SUBJECT: SEP TOPIC III-3C "Inservice Inspection of Water Control Structures"

Systematic Evaluation Program Topic Assessment

Location: San Onofre 1

Topic: III-3.C - Inservice Inspection of Water-Control Structures

Figure 1 - San Onofre - General Site Plan

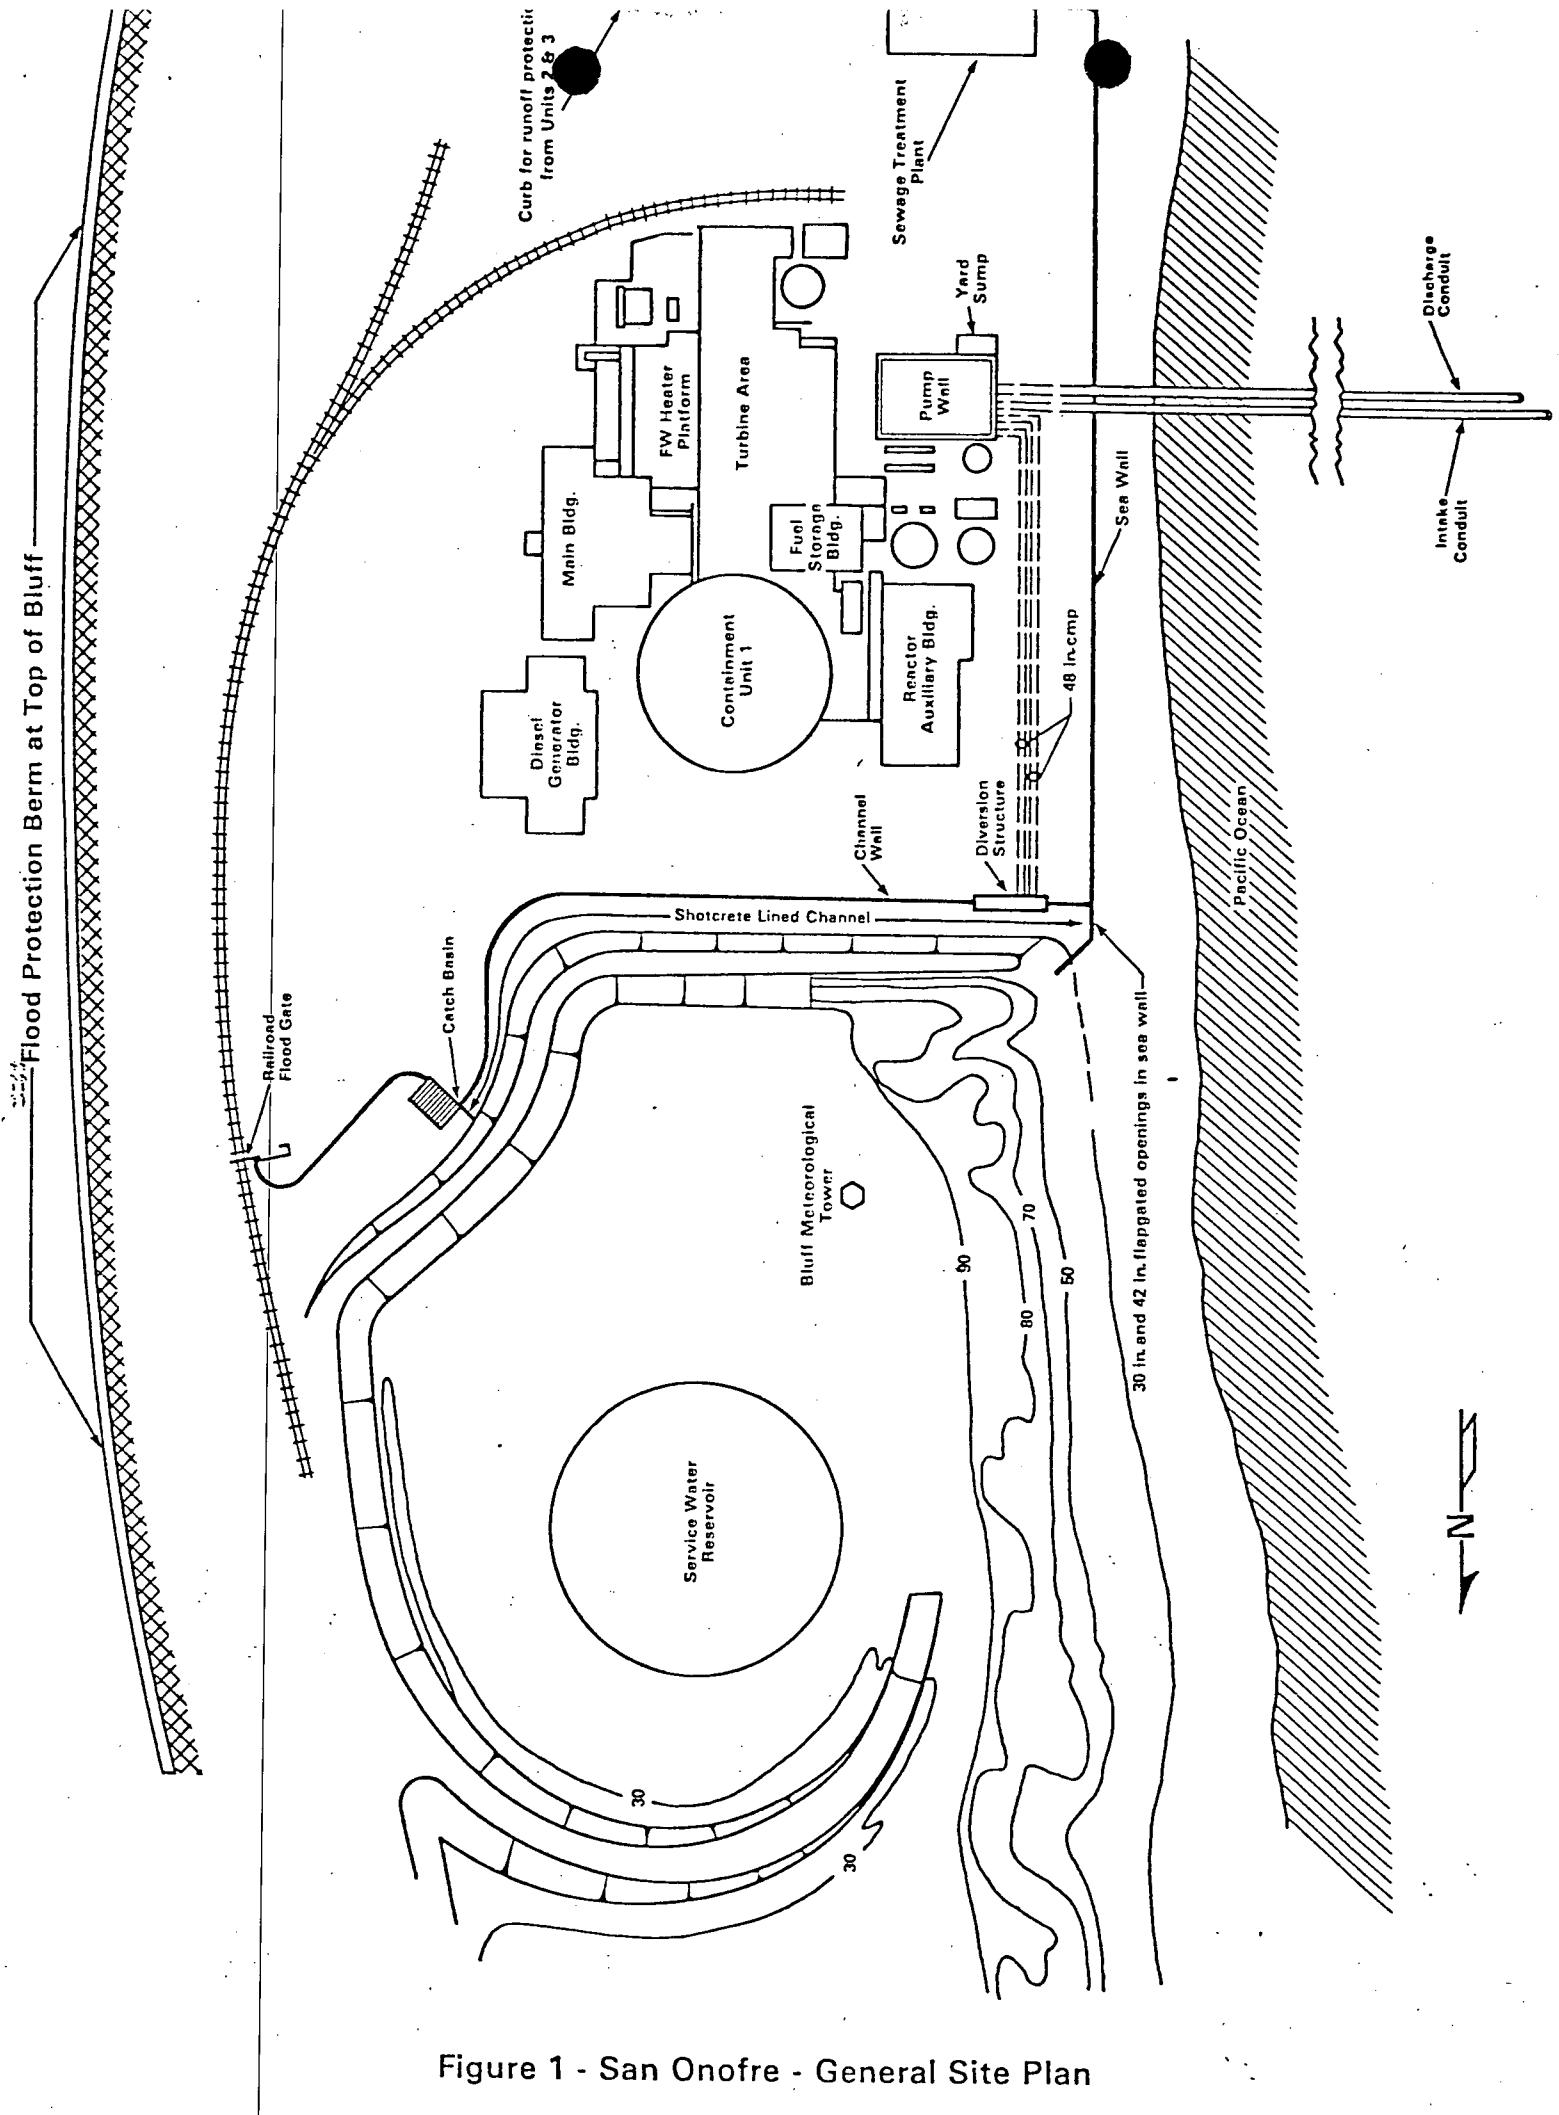
The following structures and components associated with the San Onofre Unit 1 site have been identified as requiring surveillance in accordance with applicable Commission rules and the regulatory guidance in Regulatory Guide 1.127. (See Figure 1)

- 1) North side flood protection system including: railroad gate, catch basin, shotcrete lined channel, north channel wall, existing diversion structure including two 48" corrugated metal pipes and one 30" and one 42" flap gate openings in seawall.
- 2) South side flood curb (currently under construction).
- 3) East side flood berm (currently under construction).
- 4) West side seawall and tsunami gates and the beach walkway which is currently under construction.
- 5) Yard drainage sump.

4. A formal inspection program, as outlined in Regulatory Guide 1.127, has not been established for the site flood control structures or the 3 MG Reservoir (backup cooling water system). It is the recommendation of the staff that a program be formulated and inspections subsequent to post-construction acceptance inspections for all water control structures be scheduled on a routine bases. It is our understanding that the licensee is contemplating establishing such a program and schedule for appropriate structures, varying from yearly to once every 3 to 5 years, based upon the type of structures and the potential for distress, and upon the condition and maintenance schedule for each structure. Special inspection to be performed after the occurrence of significant unusual events, such as earthquake or intense local rainfall are planned on an "as require" basis. We concur in this general schedule approach and find that the planned frequency of inspections is in accord with the Commission rules and the regulatory guidance of Regulatory Guide 1.127. However, since the licensee's present position has not been formalized into a specific program we conclude that the frequency schedule for each structure, and a copy of the developed inspection checklist for each structure should be submitted to the NRC by the licensee for staff review.
